Urban Design Guidelines in action: A review of 2 DDBP projects

Presented by Sophia Benner, Principal Planner

Review of:
The Graduate
18th & Guadalupe
SP-2023-0042C

Review of:
Block 32

SOUTH ELEVATION

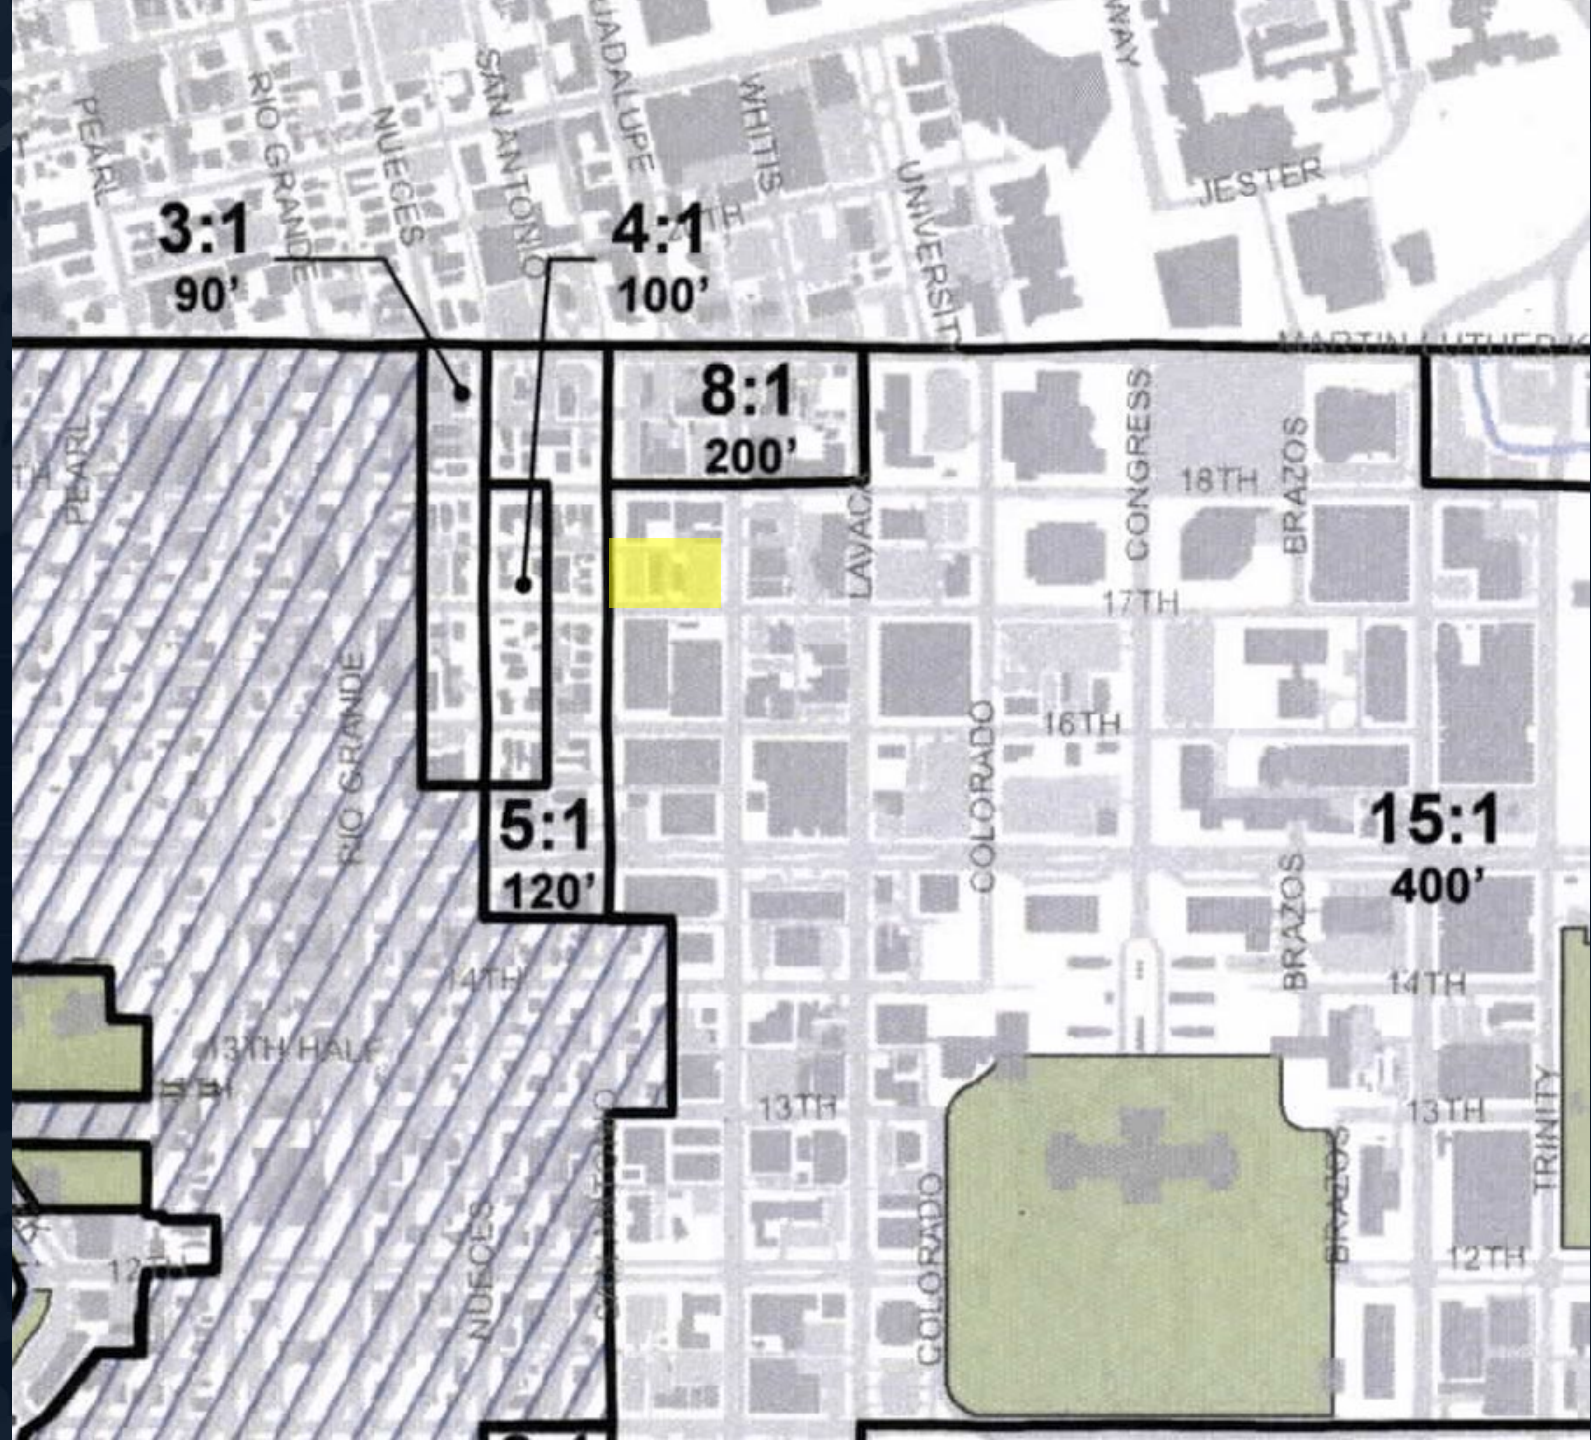
Encourage the out of scale pedestrian gathering space along San Antonio Street be brought back into scale

Encourage corner entrances to expand pedestrian access on San Antonio Street and Guadalupe Street

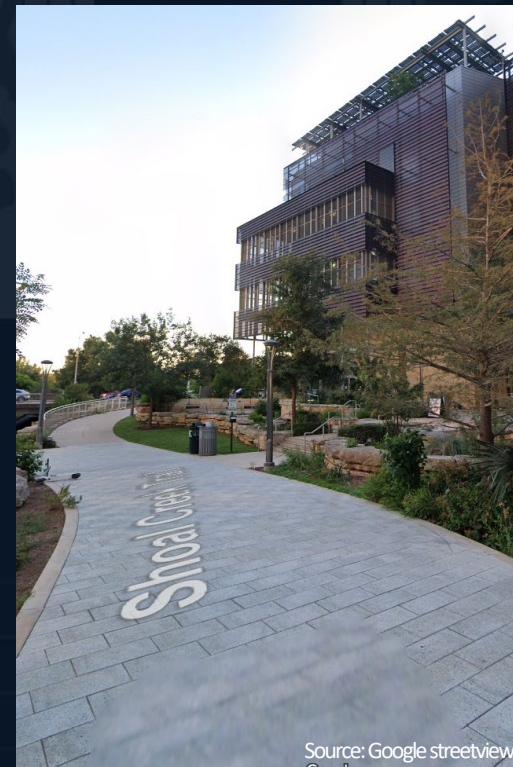
Enhance the north façade to encourage an active northeast corner To use the City of Austin standard benches

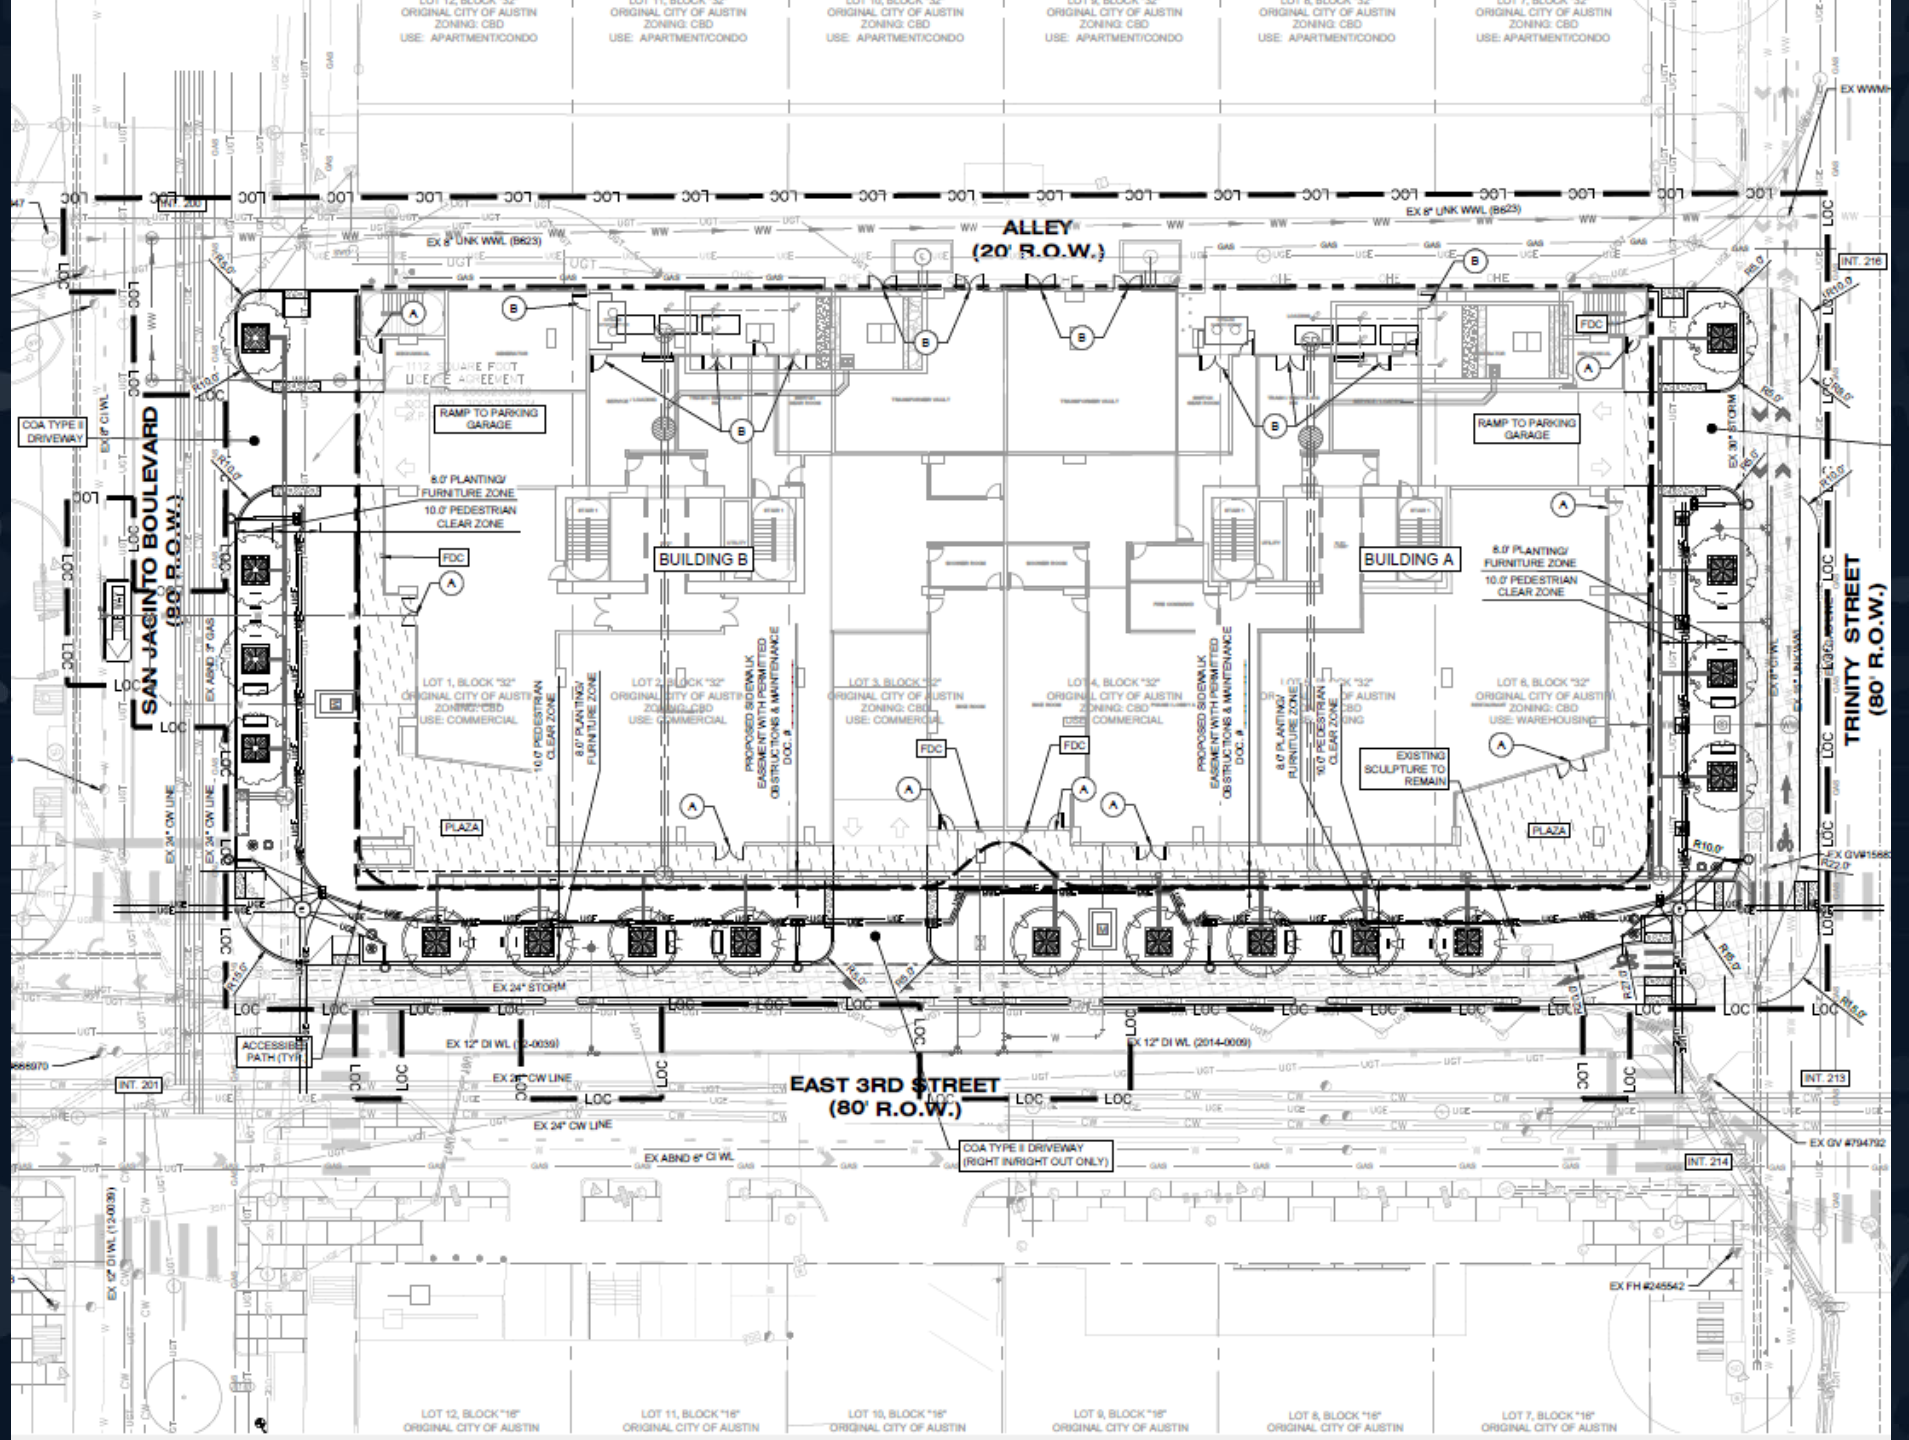
Expand food and beverage service along 18th Street to enhance the primary entrance to the food and beverage area

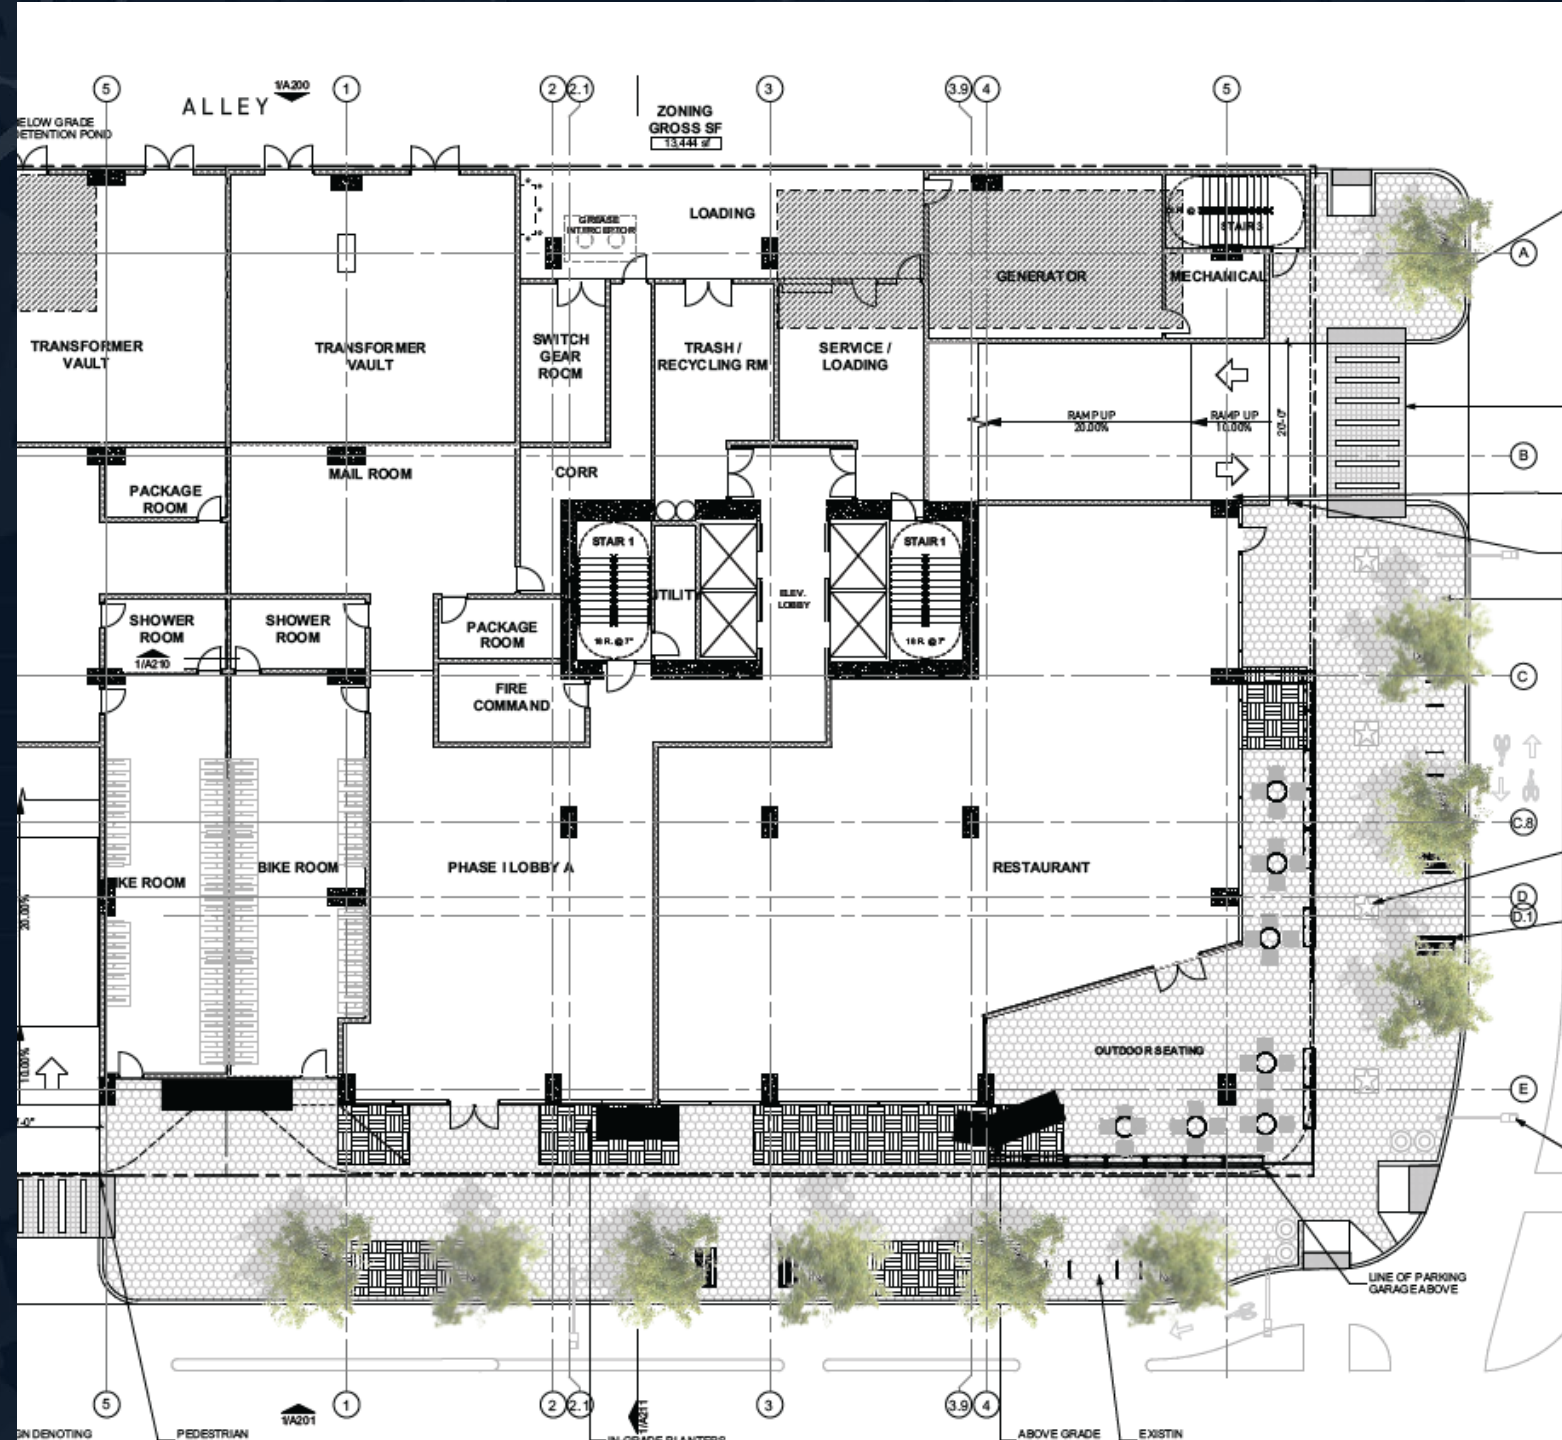
At least two different uses per half block are required. Low occupancy uses such as warehouses, storage, and parking will not be counted in the evaluation of mixed use functions.

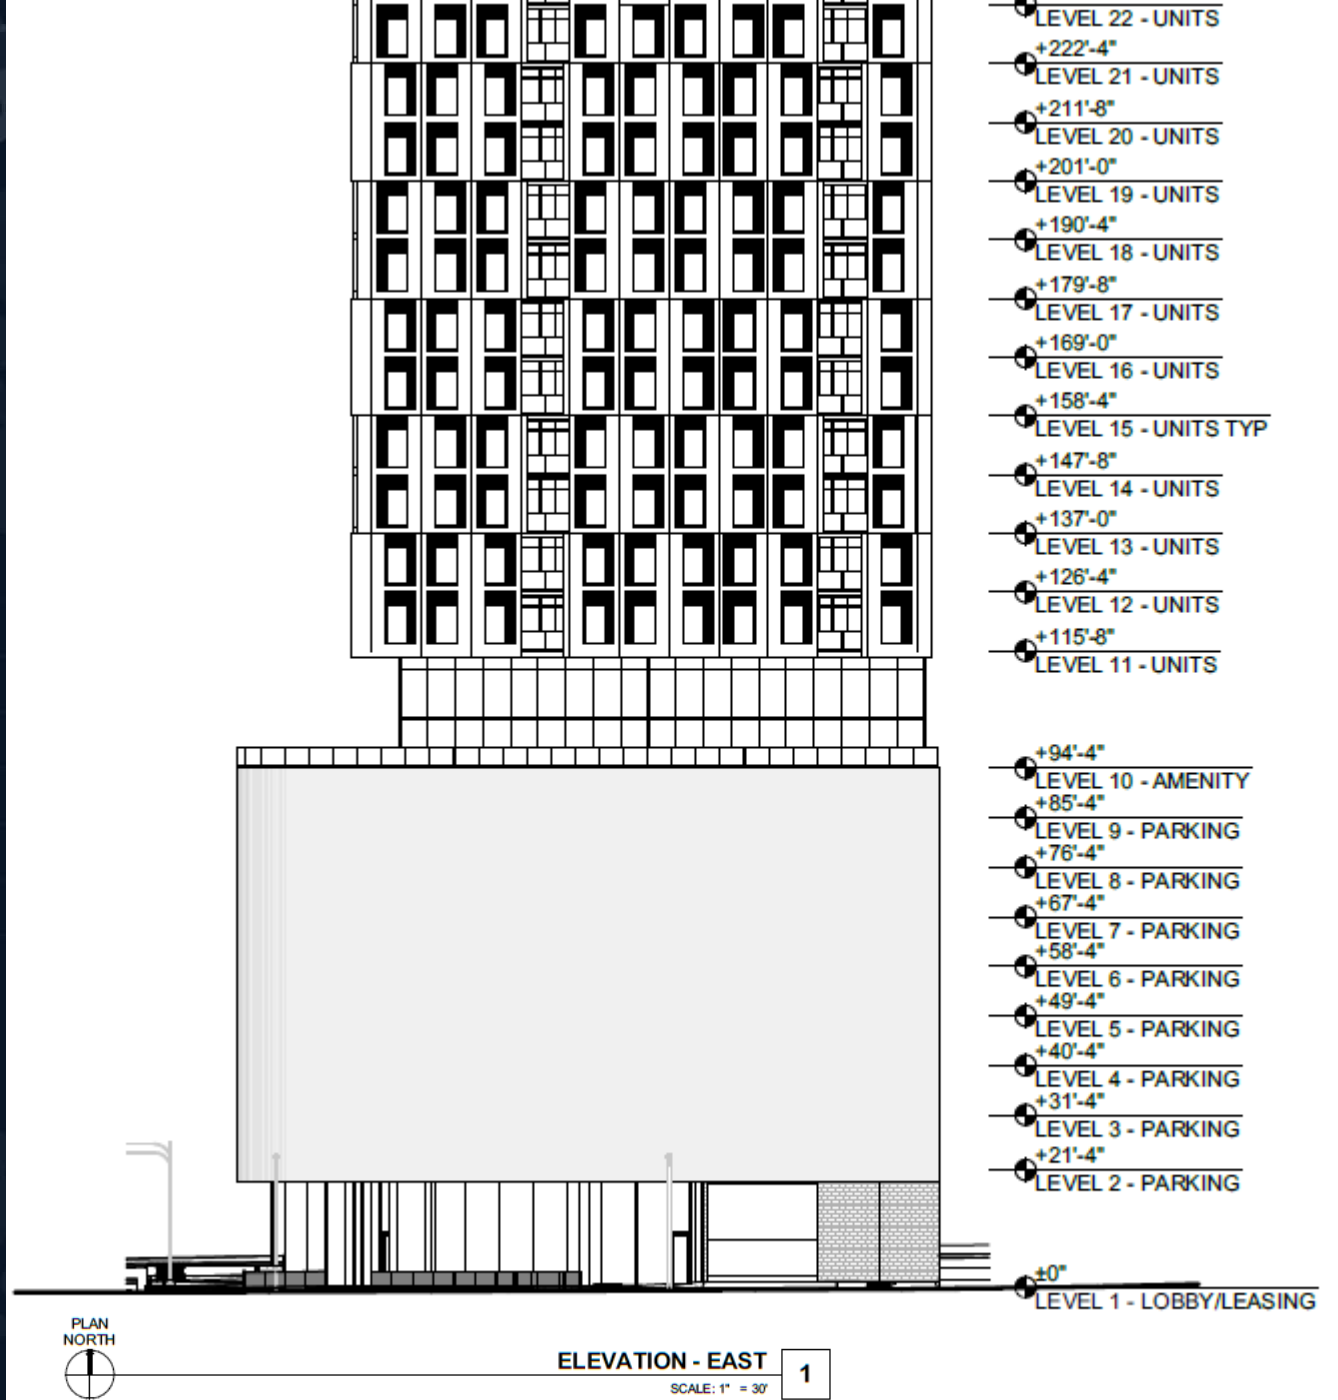
The eastern façade is just west of the Convention Center
